Bradley Heights Apartments

A 236-Unit Apartment Development Puyallup, Washington

Bradley Heights SS LLC

1-BED-INT-1 UNIT TYPE 'A' ACCESSIBLE
BASEMENT & 1st LEVEL FLOOR PLAN
1/4" = 1'-0"

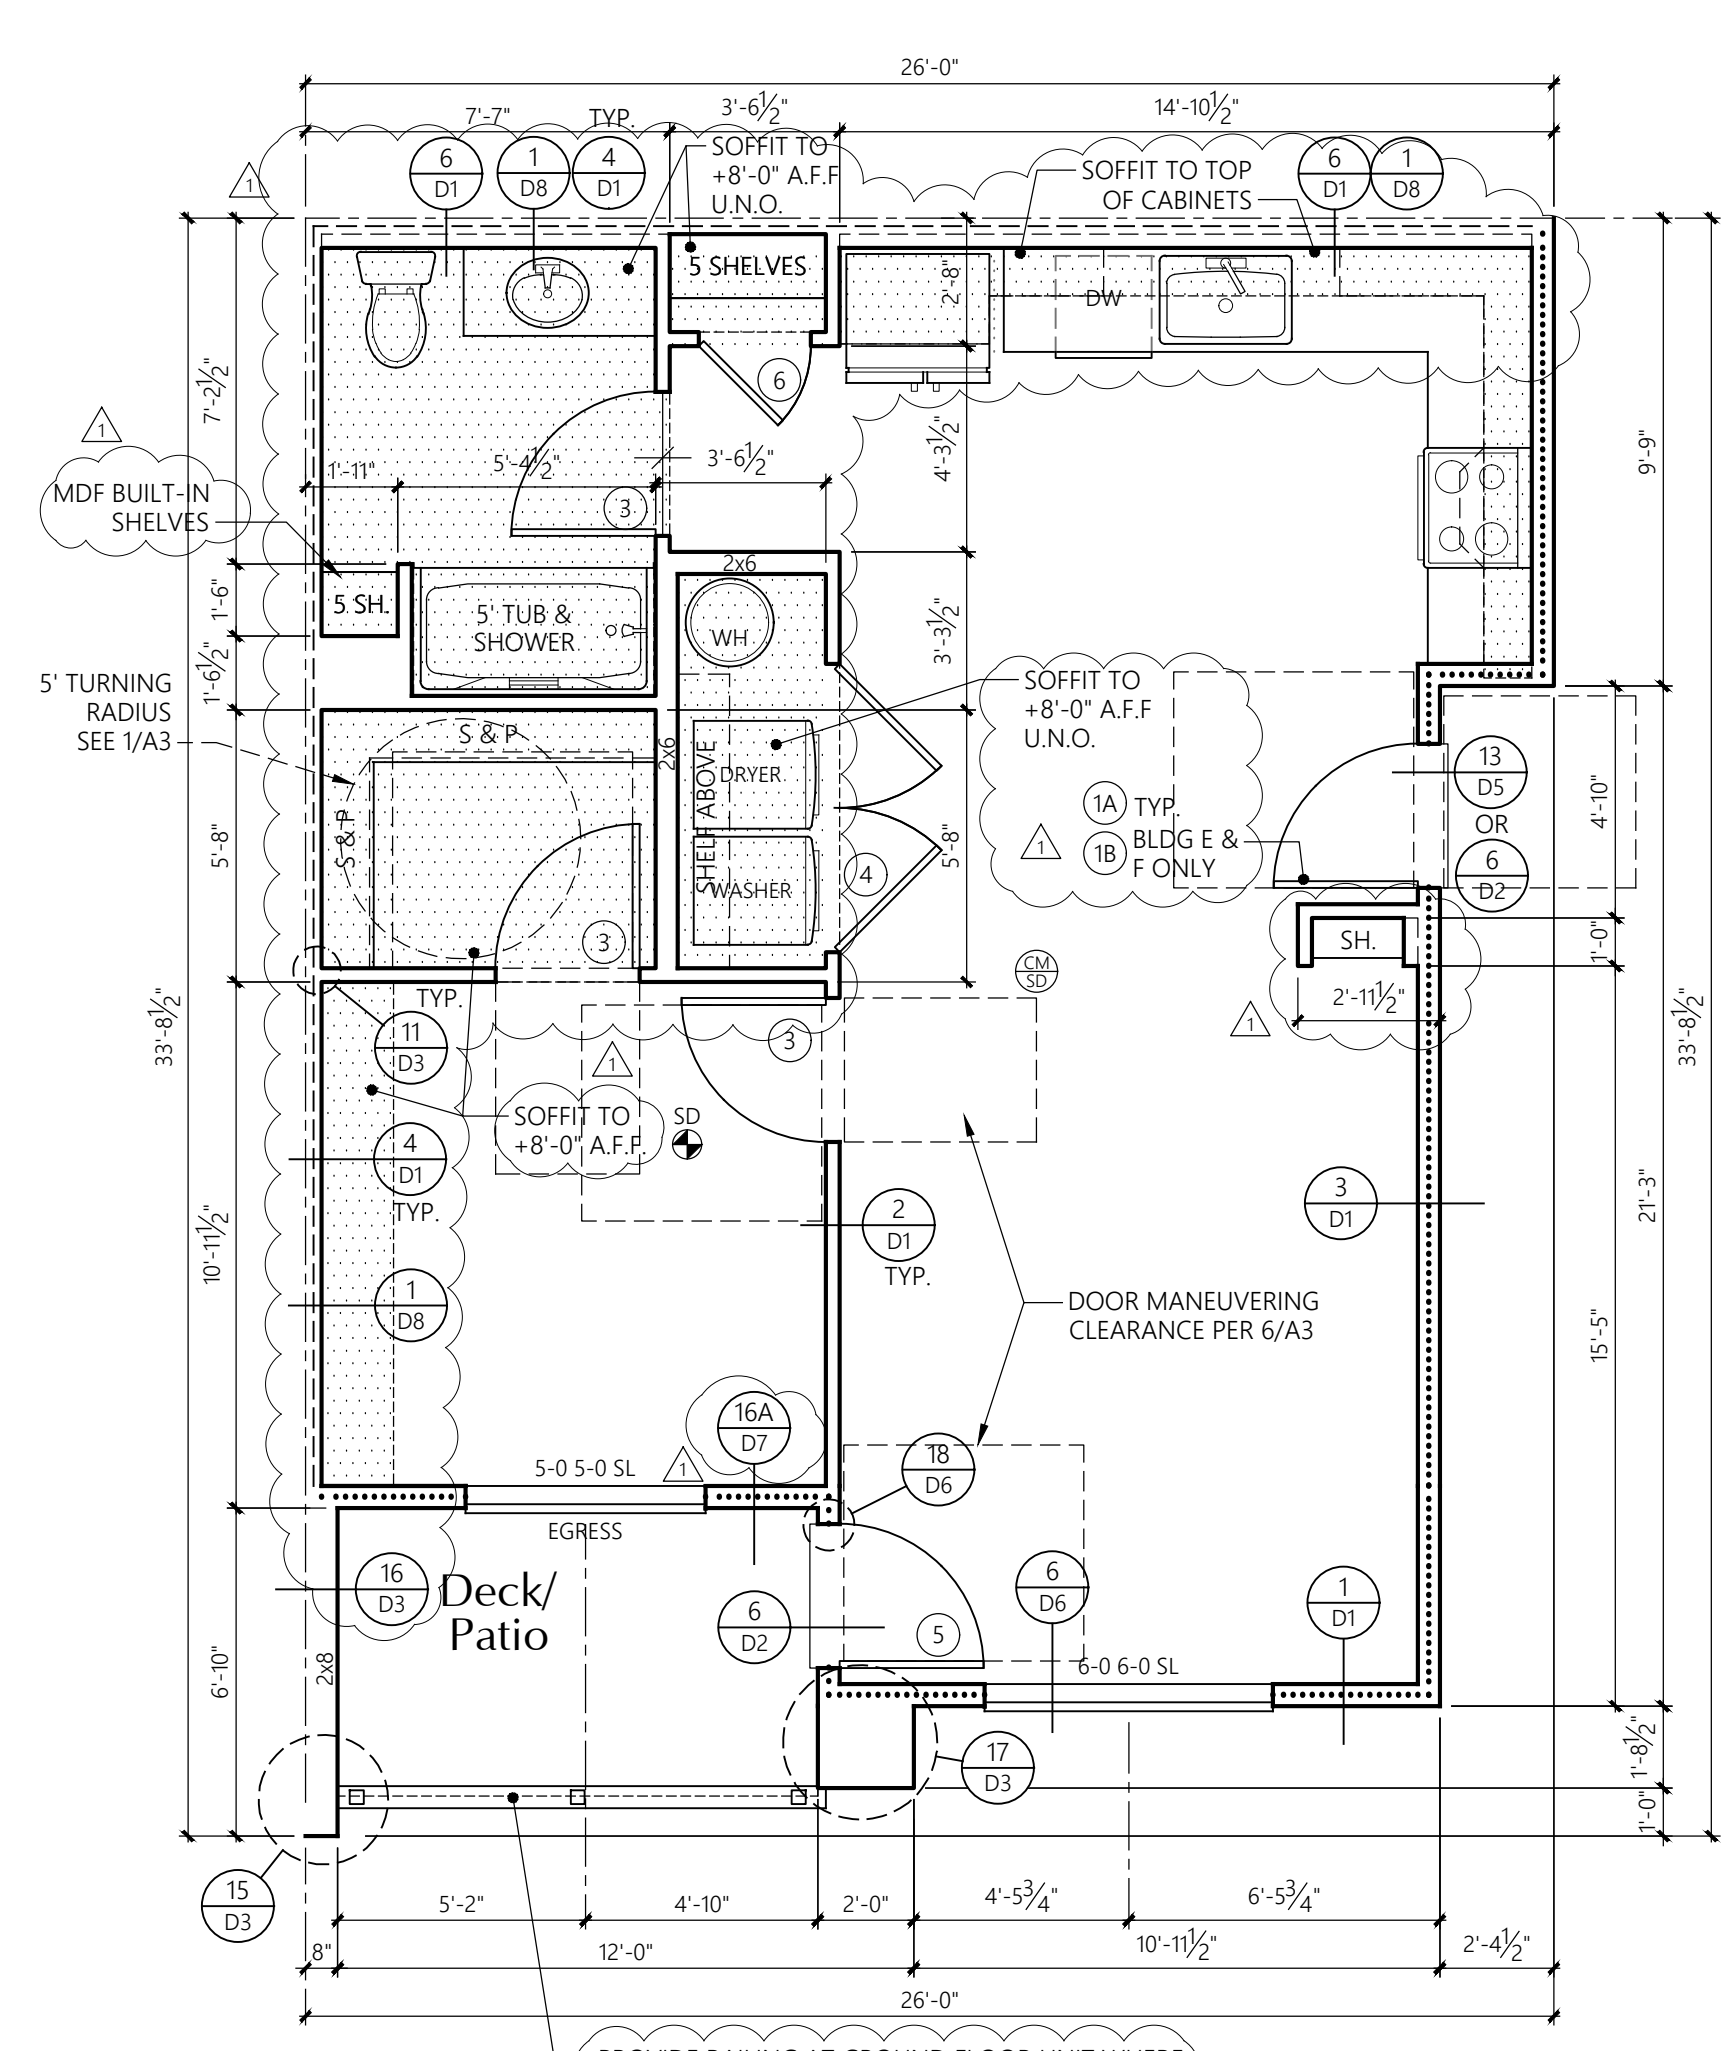
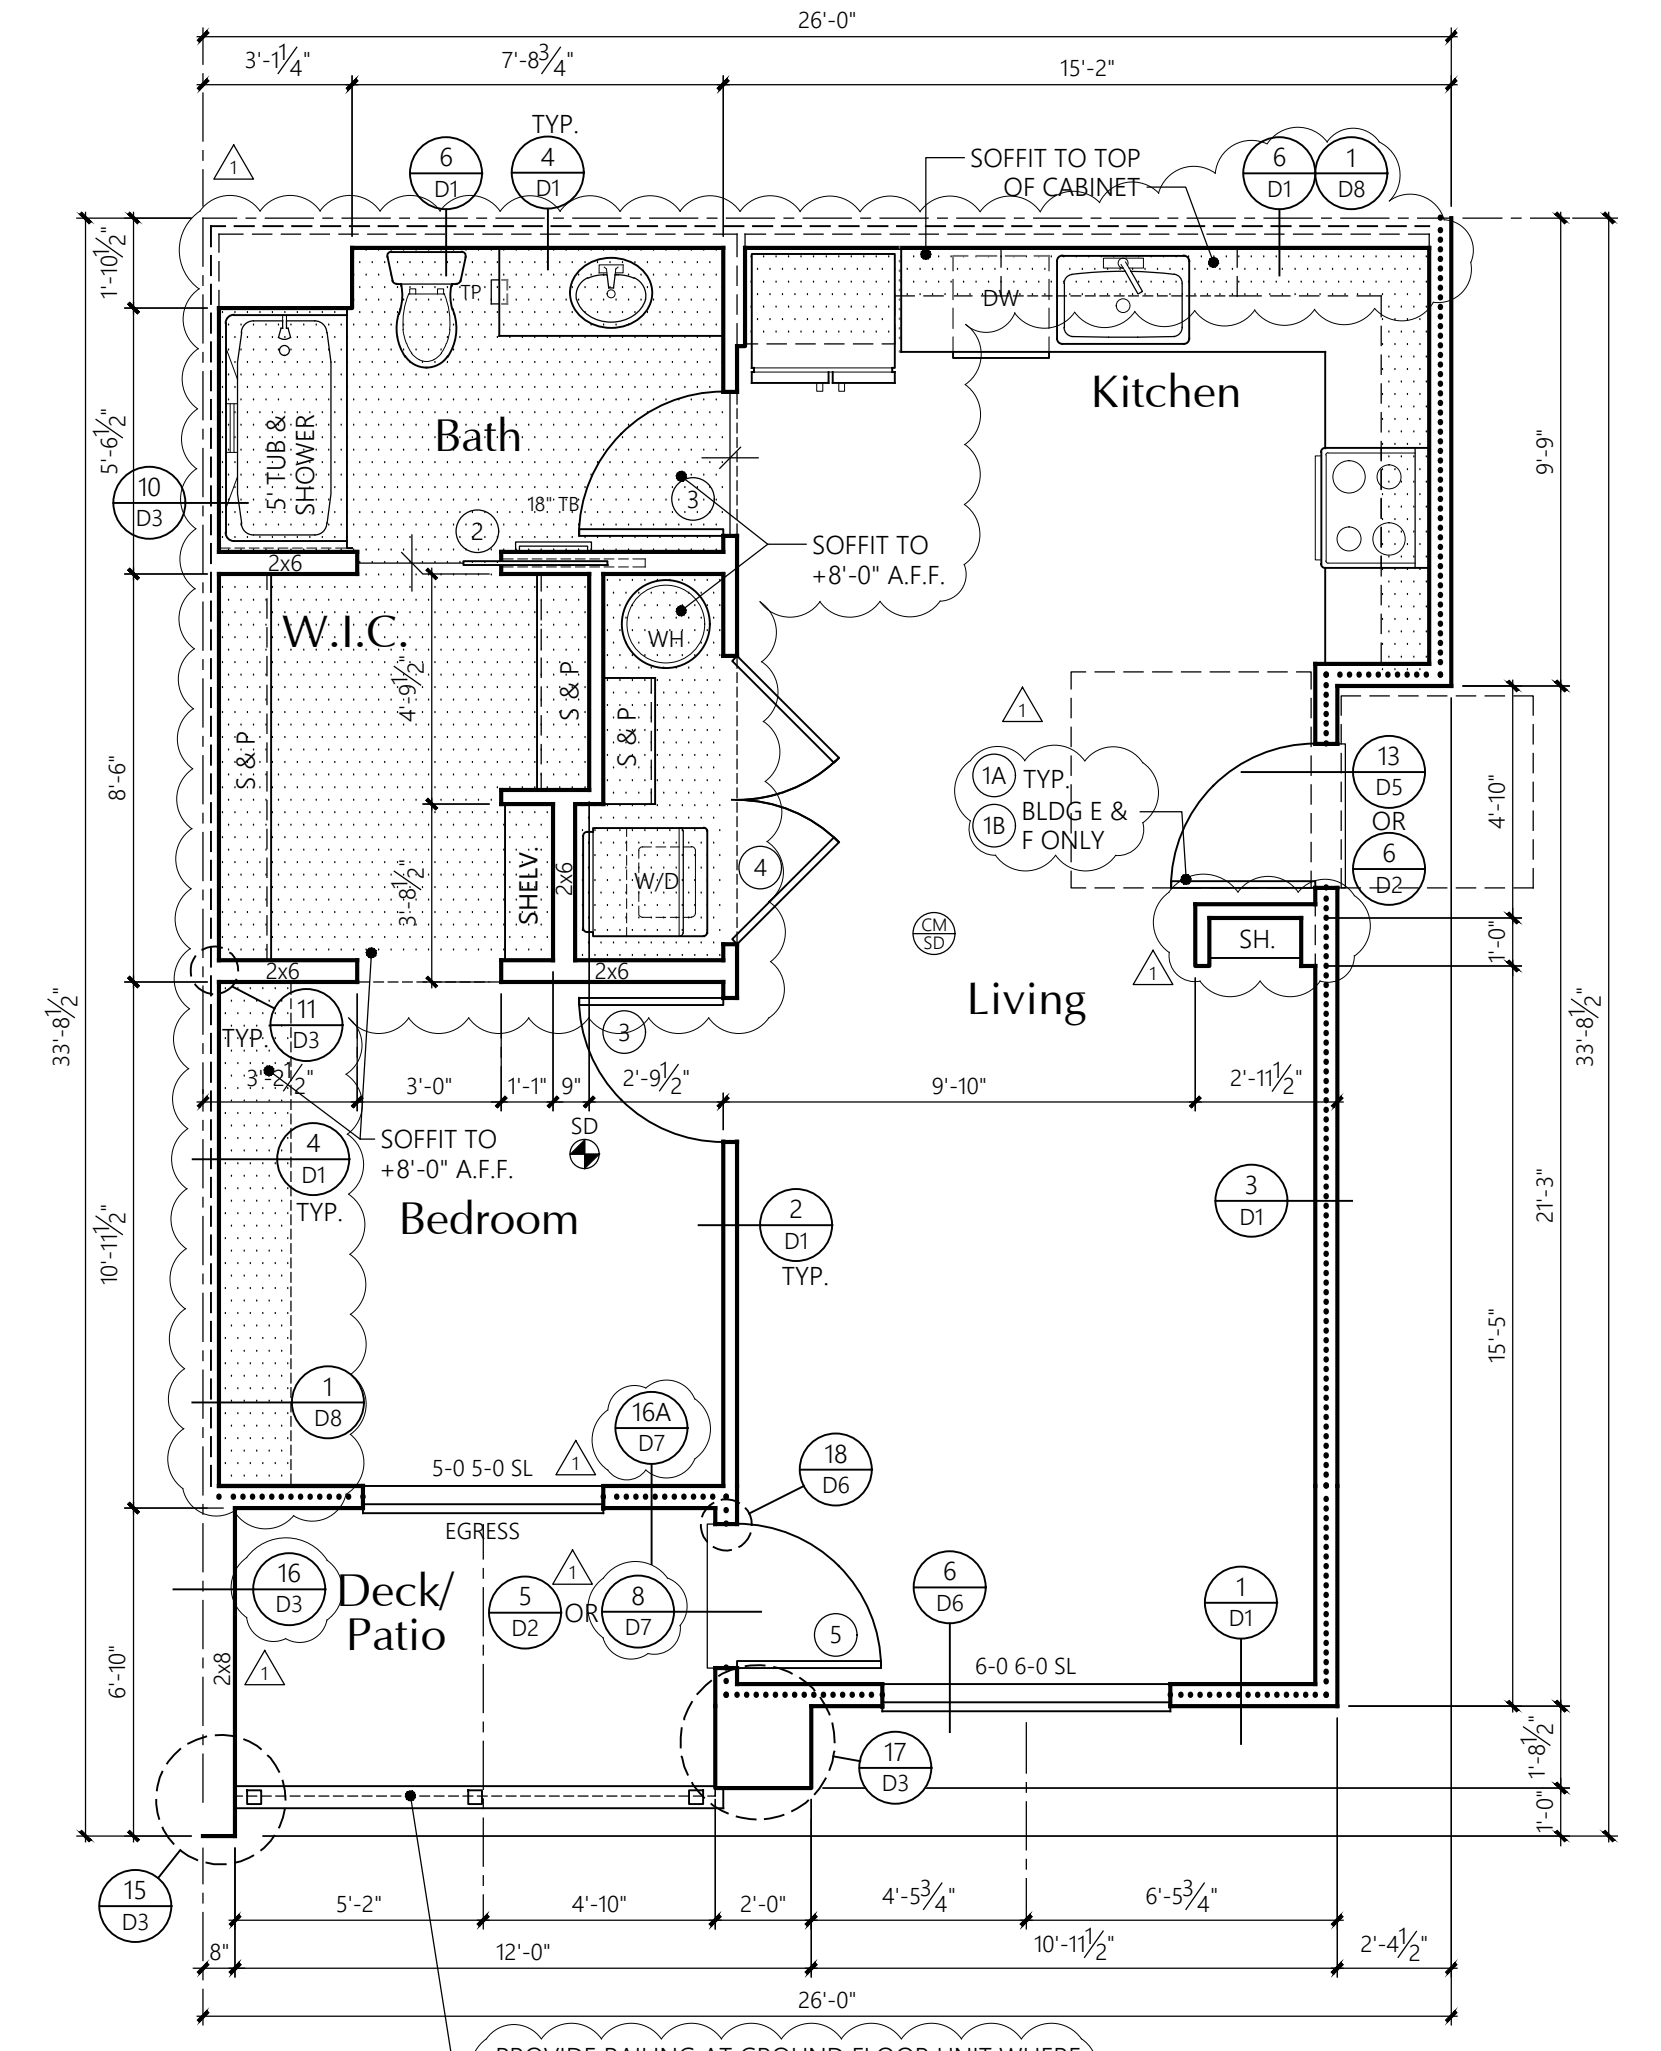
Door Key references Sheet U13 update plan or sheet numbers as needed, as there is no Sheet U13.
